# MITIGATION PLAN

### CASEY CREEK MITIGATION SITE

Subject: Mitigation Plan Report and Construction Plans Review Comment Response  
Casey Creek Mitigation Site, Wayne County  
Neuse River Basin HUC 03020201  
DMS Project ID No. 100597/Contract No. 210201-01

Figure 7. Buffer Mitigation and Nutrient Offset Concept Map  
Casey Creek Mitigation Site  
Nutrient Offset and Buffer Mitigation Plan  
Neuse River Basin (03020201)

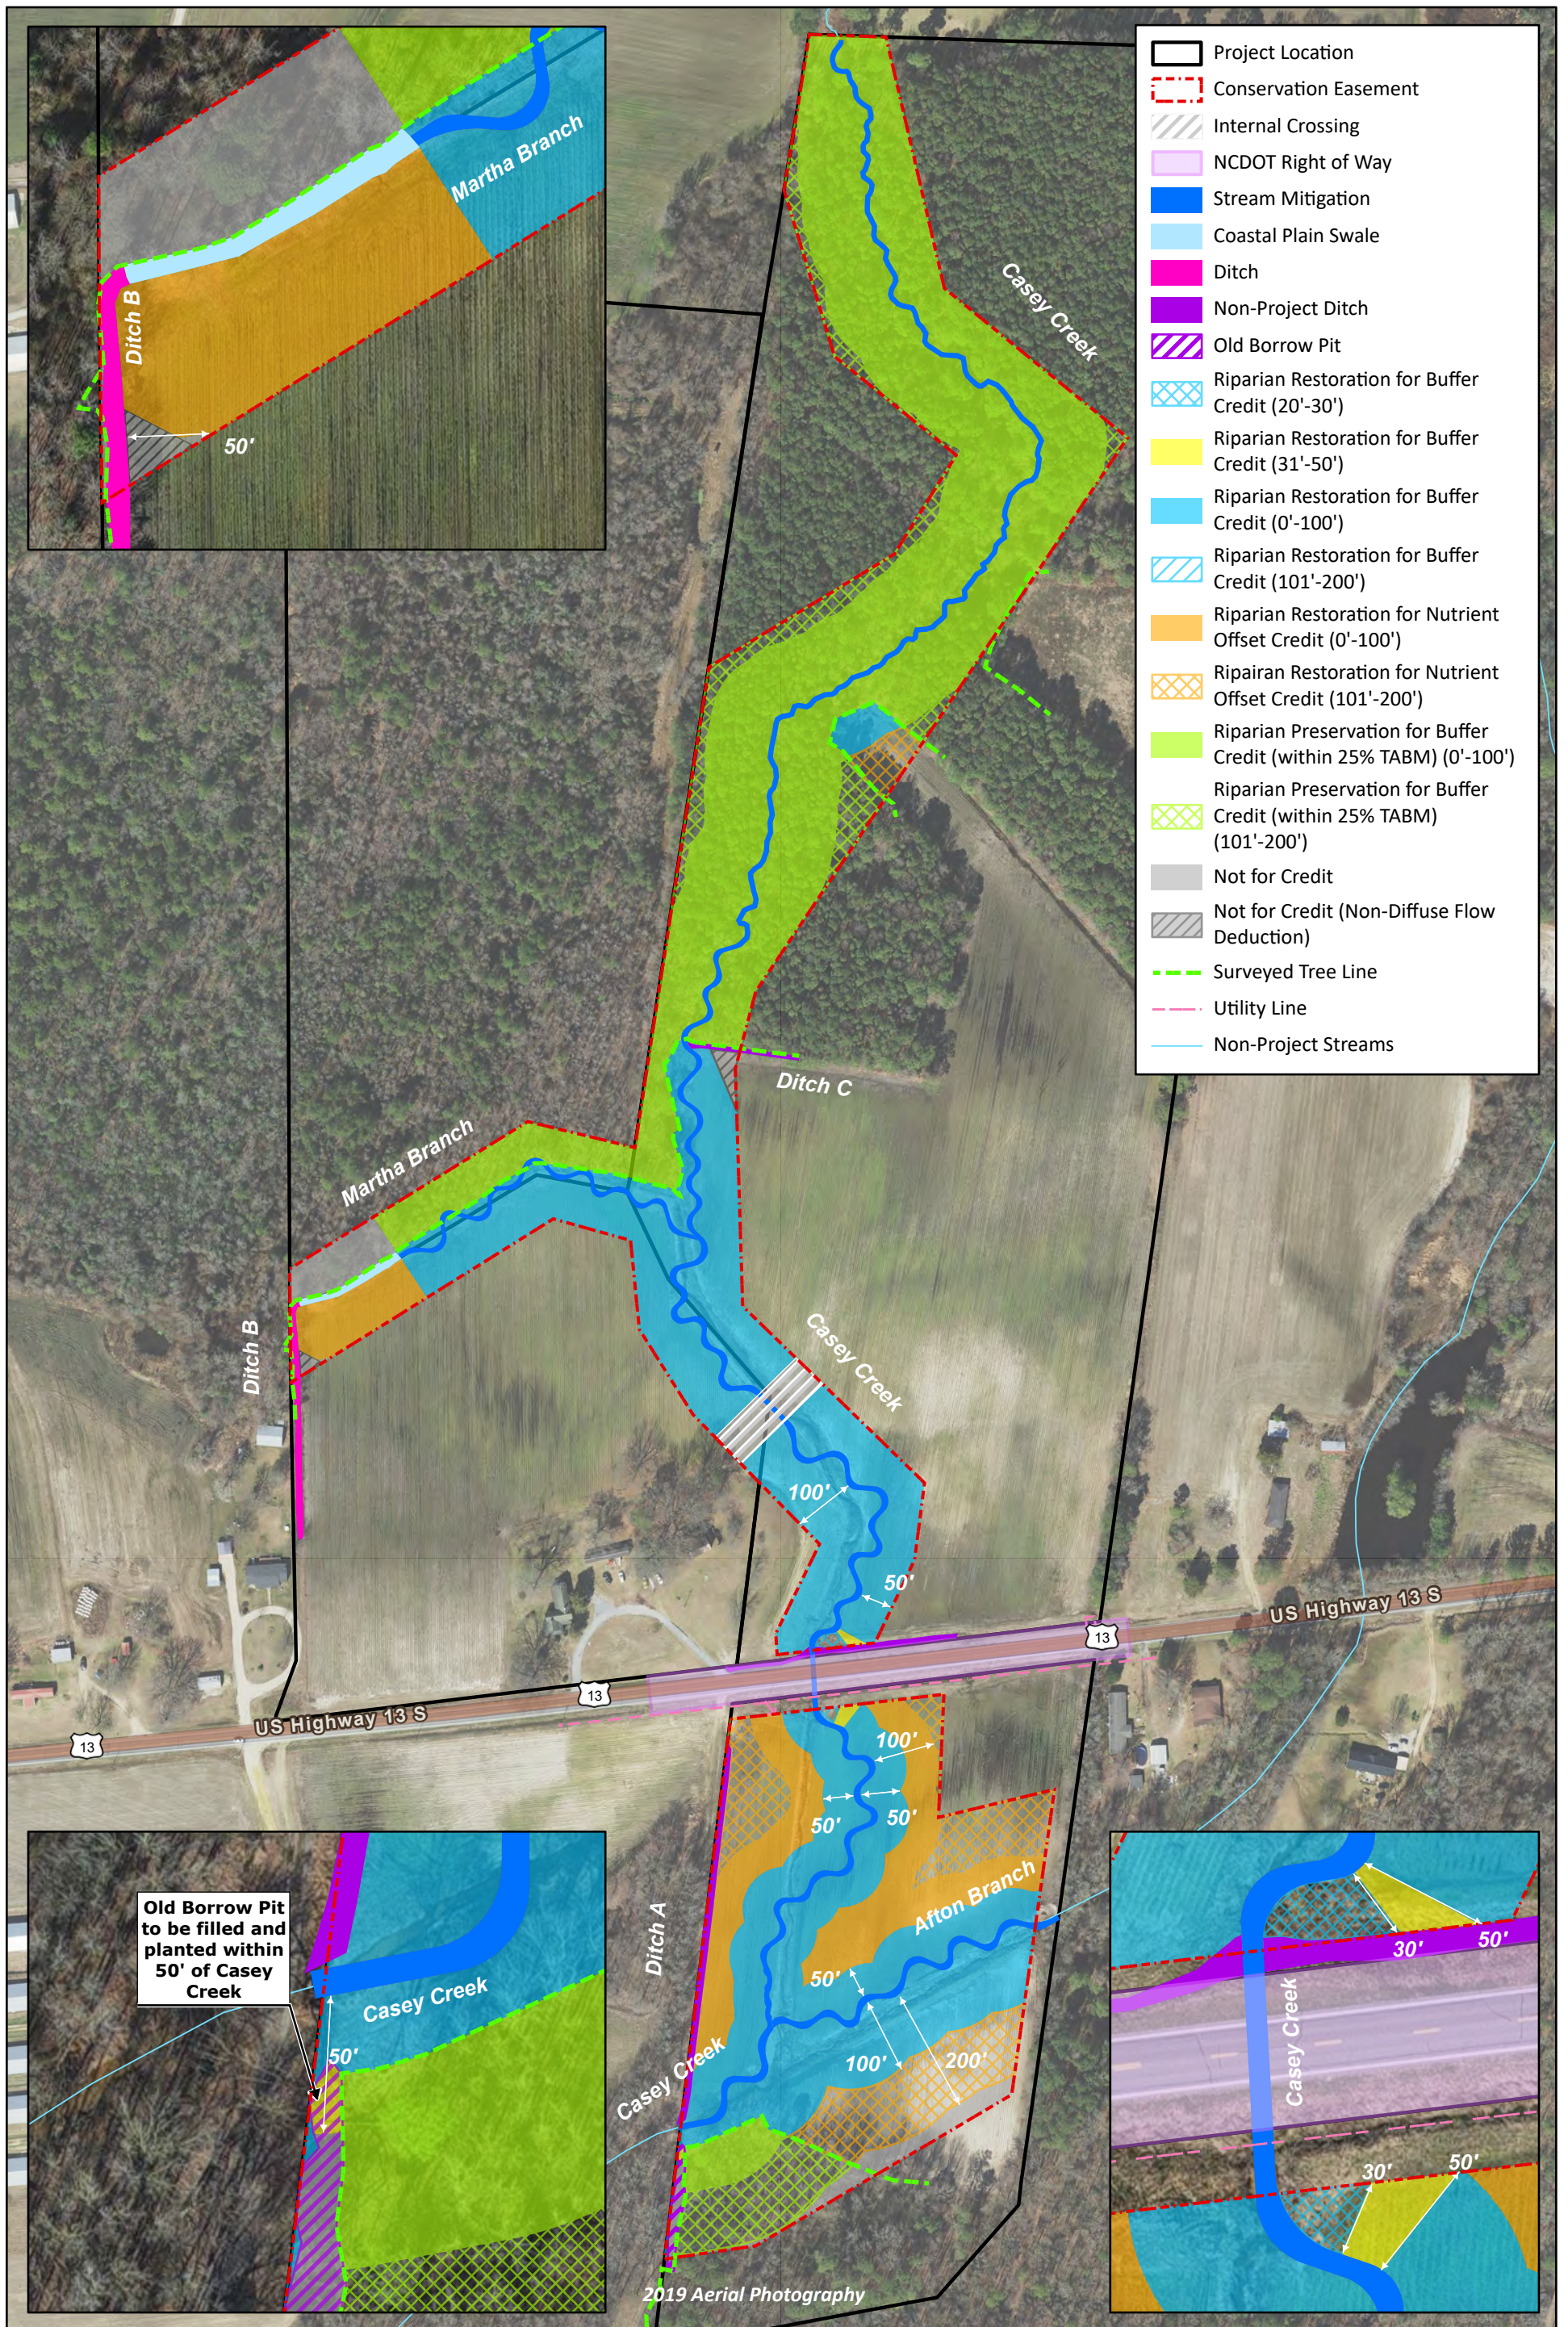
- a. There is a ditch coming into Casey Creek on the map (see Figure 7 for comments) and DWR did not see this ditch. Explain its existing hydrological connection (or not) to Casey Creek and what is being proposed on this ditch as part of the buffer and stream plans.

- e. Figure 7 shows a small ag field where restoration for both buffer and nutrient offset along Casey Creek (see comment on figure 7) is being proposed. However, this area is not shown in Appendix E on plan sheet 3.2 as being proposed to be planted. Explain and address accordingly.

**No comments were seen on Figure 7 related to a ditch that was not assessed during the site viability visit. If the feature in reference is one called out on Figure 3, then it is not a ditch. On aerial imagery, there is a dark line bordering an area of existing forest running northwest that appears to potentially be a ditch. However, Wildlands investigated the area during the Plan development, and no ditch was found. The area might have been temporarily saturated when the aerial photograph was taken, making it appear as a ditch.**

***The area in reference not included on Plan Sheet 3.2 was an oversight. Thank you for catching this. The area is now shown on Plan Sheet 3.2 as being planted.***
